**Agenda Item 2  
May 12, 2014**

**SUBJECT:** Approval of the request of Stucky Vitale Architects for Detroit Metropolitan Credit Union JSP12-69, for Revised Preliminary Site Plan approval. The subject property is located at the northeast corner of the intersection of Main Street and Novi Road in the TC-1, Town Center District. The development area is 0.83 acres and the applicant is proposing an approximately 5,686 square foot Detroit Metropolitan Credit Union.

# Detroit Metropolitan Credit Union JSP12-69

## Planning Review

Vicinity Aerial Photo for Proposed Detroit Metropolitan Credit Union

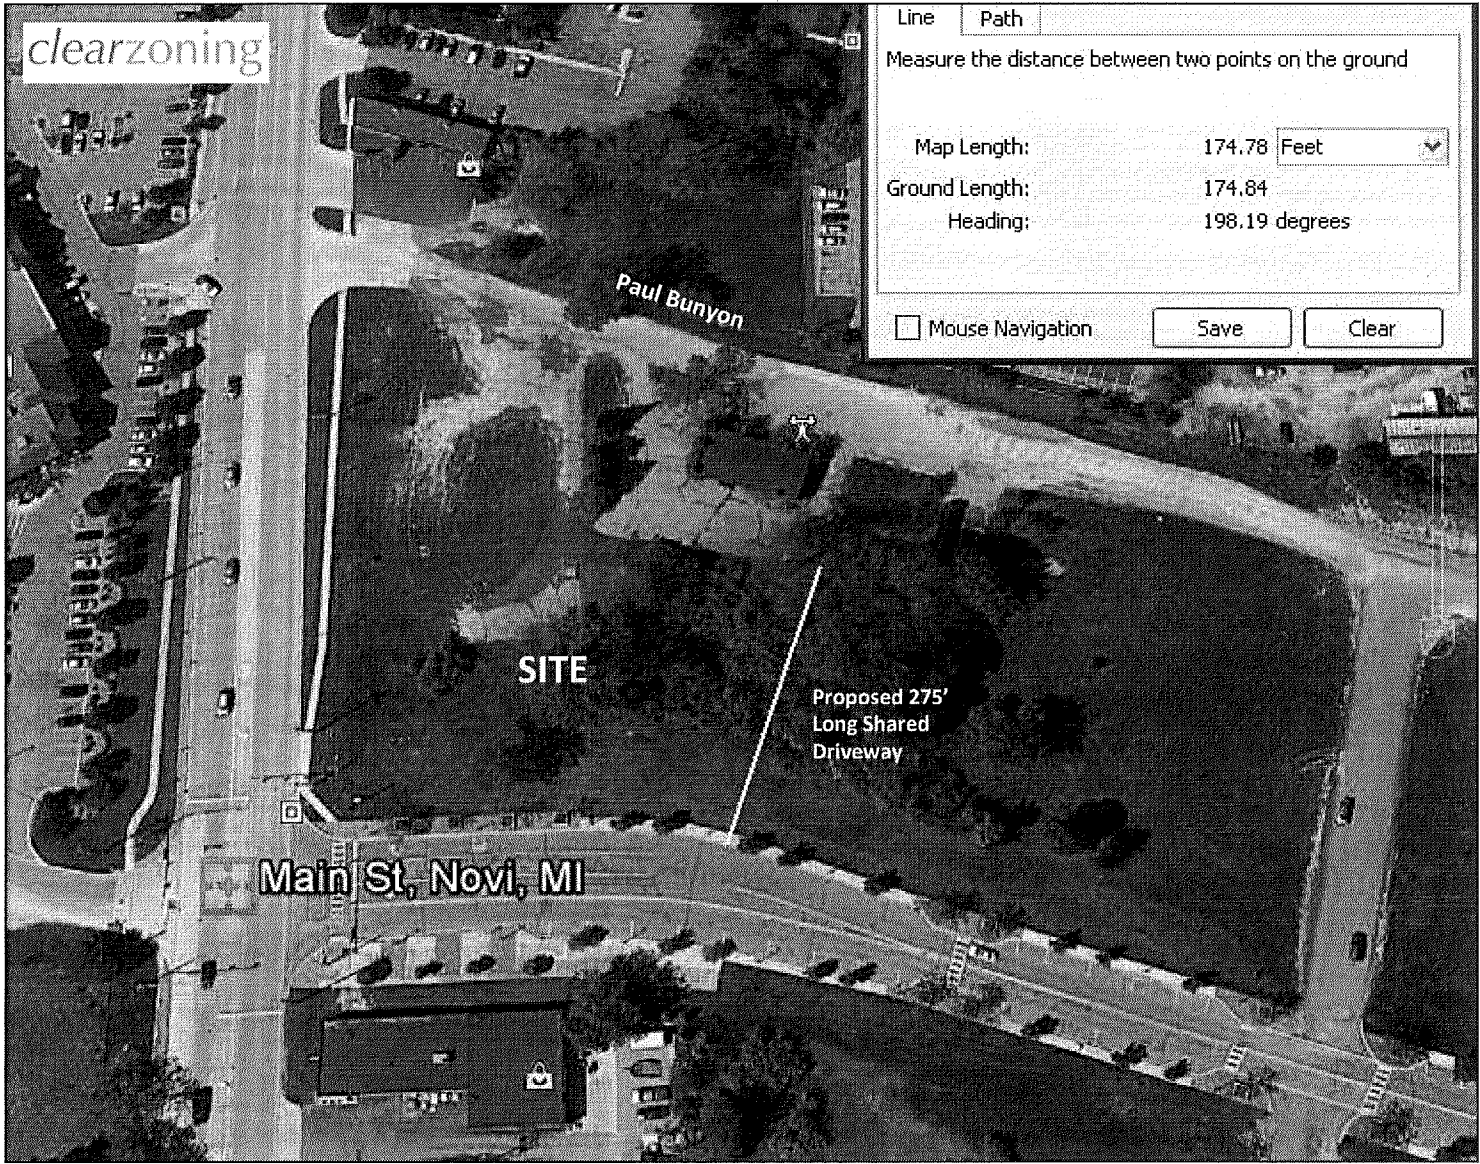
6. The proposed shared driveway would end 175 ft north of the north curb of Main Street. As shown on our attached aerial, this would end that driveway just a few feet short of existing pavement that connects to Paul Bunyon. Since we first raised this issue, the applicant has indicated that “the road will be barricaded.” The curb now proposed at the end of this drive would not, by itself, constitute “effective barricading” (to quote part of our earlier letter). **The final site plan should propose, per page 605a of the 2011 Michigan Manual on Uniform Traffic Control Devices (MMUTCD), a Type 3 barricade for “total closure,” mounted on wood posts embedded in the ground a short distance behind the proposed curb.**

Sheet Title:  
GRADING & UTILITY PLAN

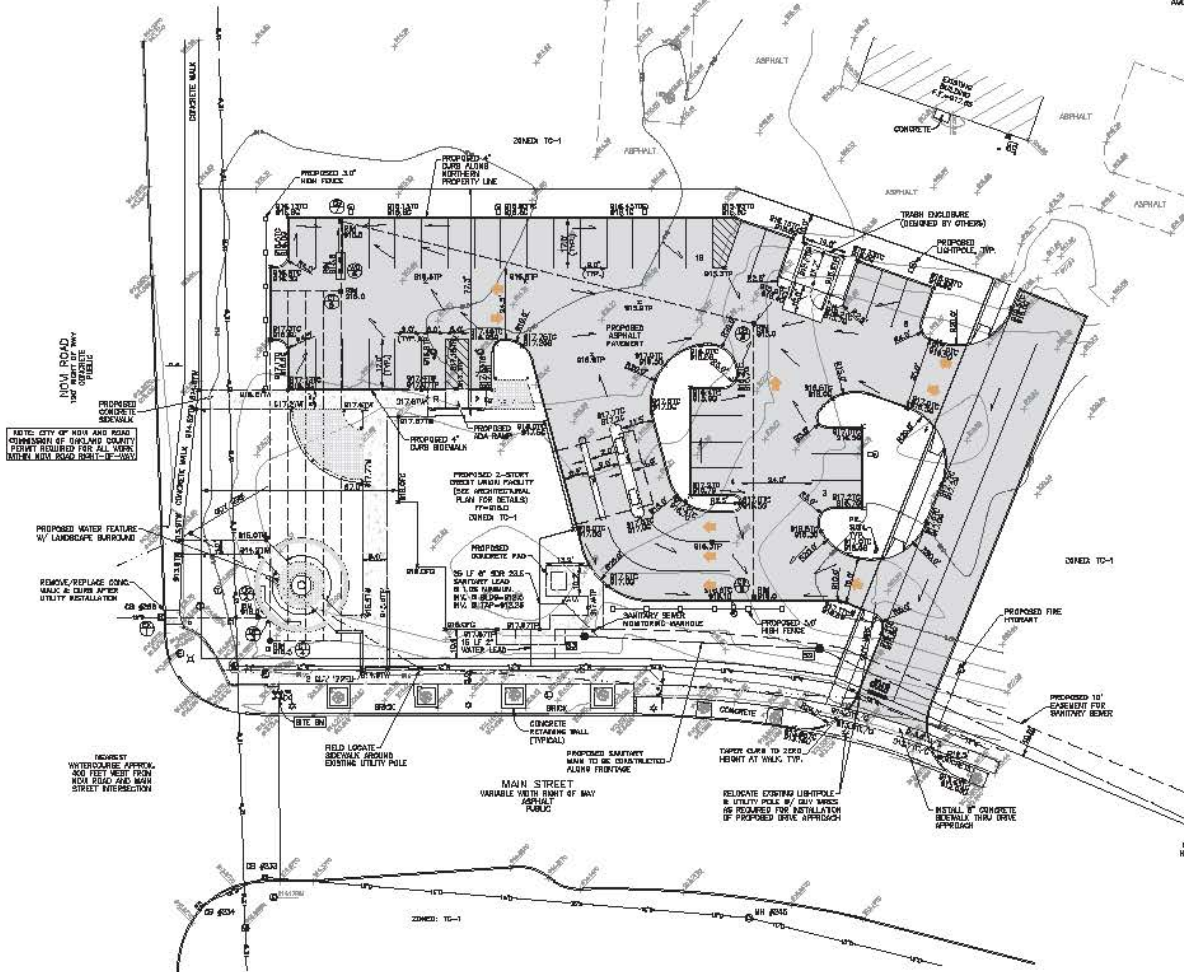
4. Provide a profile for the proposed water main with the pipe invert and stationing of all valves, fittings, flanges, hydrants, blow-offs, high and low points, and any other appurtenances.
5. Three (3) sealed sets of revised utility plans along with the MDEQ permit application (1/07 rev.) for water main construction and the Streamlined Water Main Permit Checklist should be submitted to the Engineering Department for review, assuming no further design changes are anticipated. Utility plan sets shall include only the cover sheet, any applicable utility sheets and the standard detail sheets.

6. Revise the sanitary sewer easement to a 20 ft wide easement centered on the proposed sanitary sewer.
7. Provide a profile of the proposed sanitary sewer showing a minimum cover of 4 feet.

10. Provide a profile of the proposed storm sewer showing a minimum cover of 3 feet. Indicate all structure types and diameters.
11. Provide hydraulic calculations verifying that the storm sewer network on Novi Rd is capable of accepting the proposed discharge from the site.

15. Verify that the proposed feature at the corner of Novi Rd. and Main Street does not conflict with the underground detention system. The applicant must also demonstrate that the underground detention system is capable of carrying the load imposed by the proposed feature.

Sheet Title:  
**STORM WATER  
 MANAGEMENT PLAN**

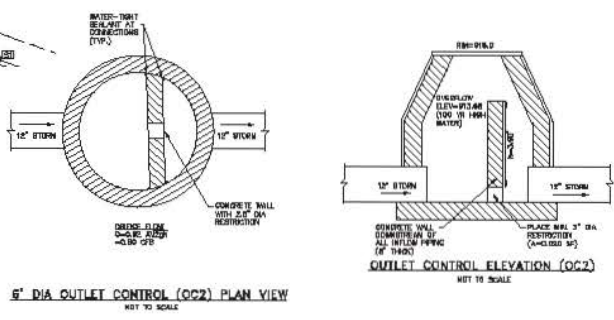
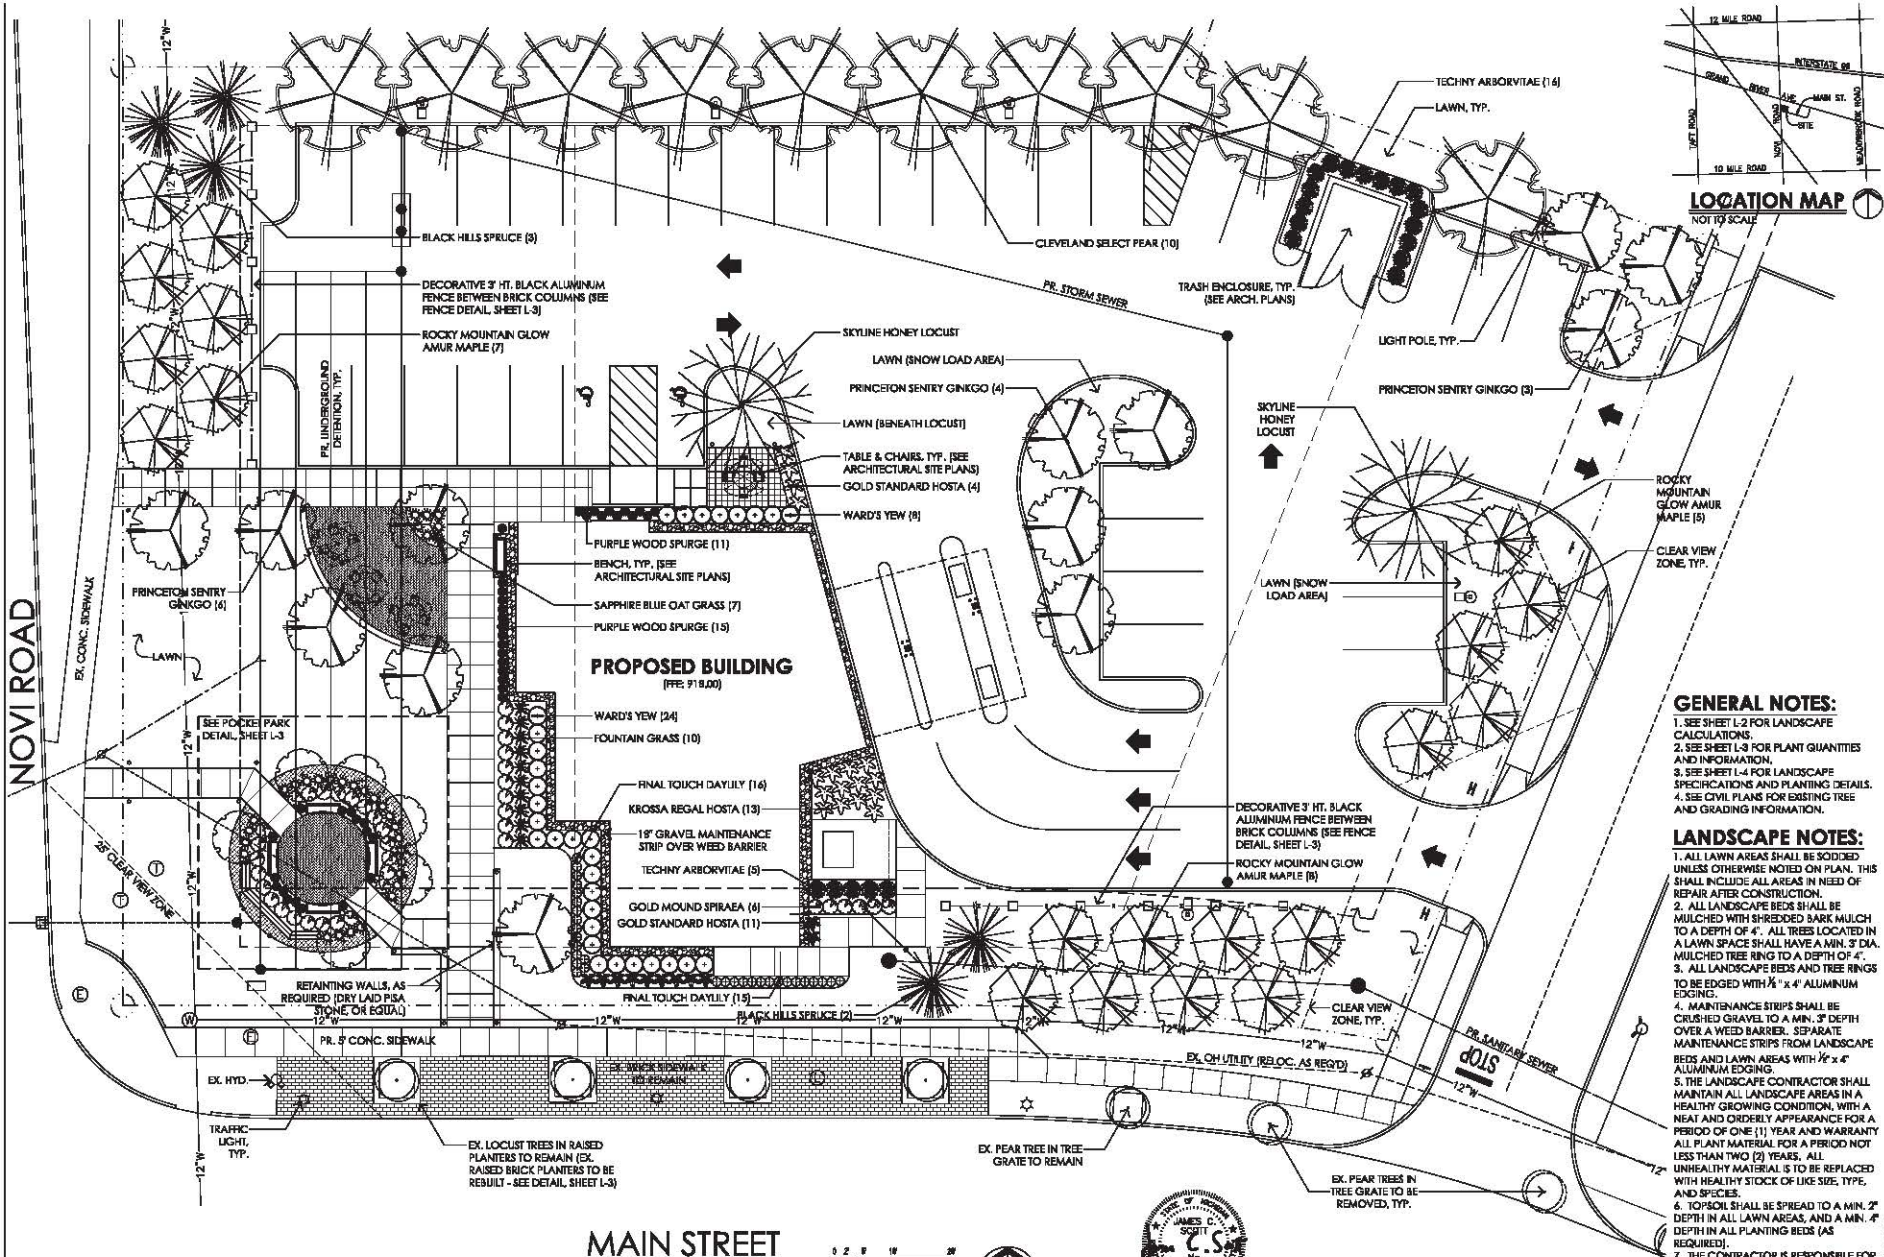
14. Provide an underground detention system cross-section with critical elevations (bankfull and 100-year storm hydraulic grade lines) demonstrating that the detention system is 3 feet above ground water and has the required 1 foot of freeboard between the high water elevation and the subgrade below the pavement.

16. Revise the composite 'c' factor calculation to ' $26,227/38,637=0.68$ ' from ' $38,637/26,227=0.68$ ' as shown.

Sheet Title:  
PHOTOMETRIC  
STUDY (GASSER BUSH  
ASSOCIATES)

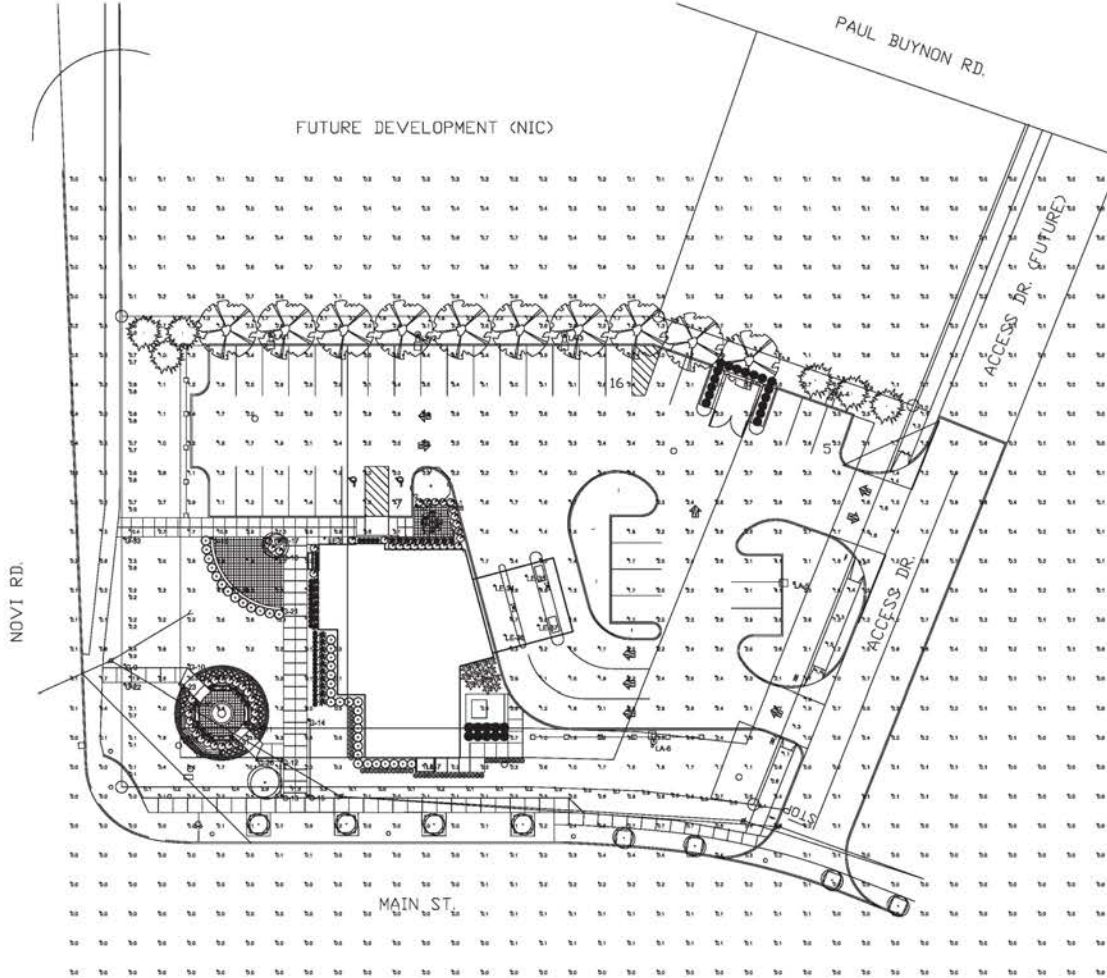
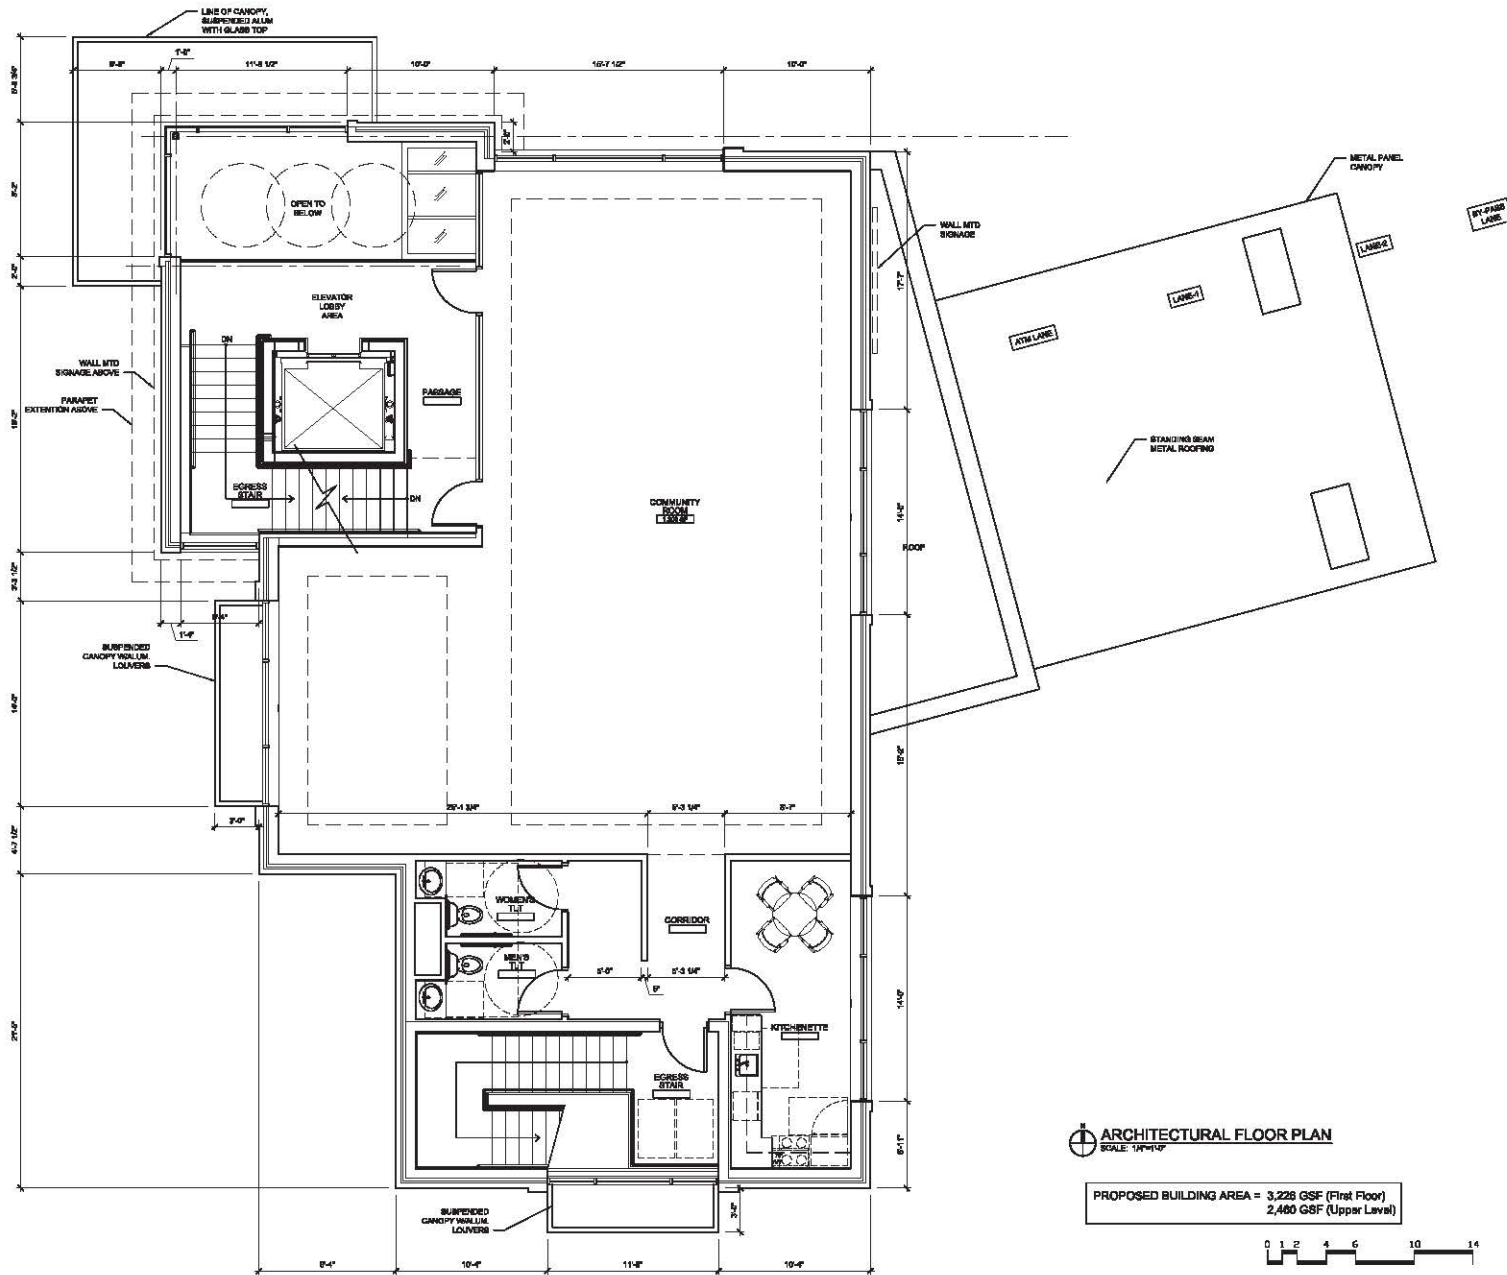
| Item                                   | Required  | Meets Requirements? | Comments   |
|--|---|---------------------|--|
| Lighting Plan (Section 2511.2.a.2)     | Specifications for all proposed and existing lighting fixtures including: <ul style="list-style-type: none"> <li>▪ Photometric data</li> <li>▪ Fixture height</li> <li>▪ Mounting &amp; design</li> <li>▪ Glare control devices</li> <li>▪ Type and color rendition of lamps</li> <li>▪ Hours of operation</li> <li>▪ Photometric plan</li> </ul> | <b>No</b>           | <p><b>The applicant should include manufacturer's specifications for all proposed fixtures. At a minimum, it appears under canopy fixtures are proposed with specifications not included.</b></p> <p><b>The applicant should include the hours of operation.</b></p> |
| Required Notes (Section 2511.3.b)      | - Electrical service to light fixtures shall be placed underground<br>- No flashing light shall be permitted<br>- Only necessary lighting for security purposes and limited operations shall be permitted after a site's hours of operation.  | <b>No</b>           | <p><b>The applicant should add the required notes to the photometric plan.</b></p>   |
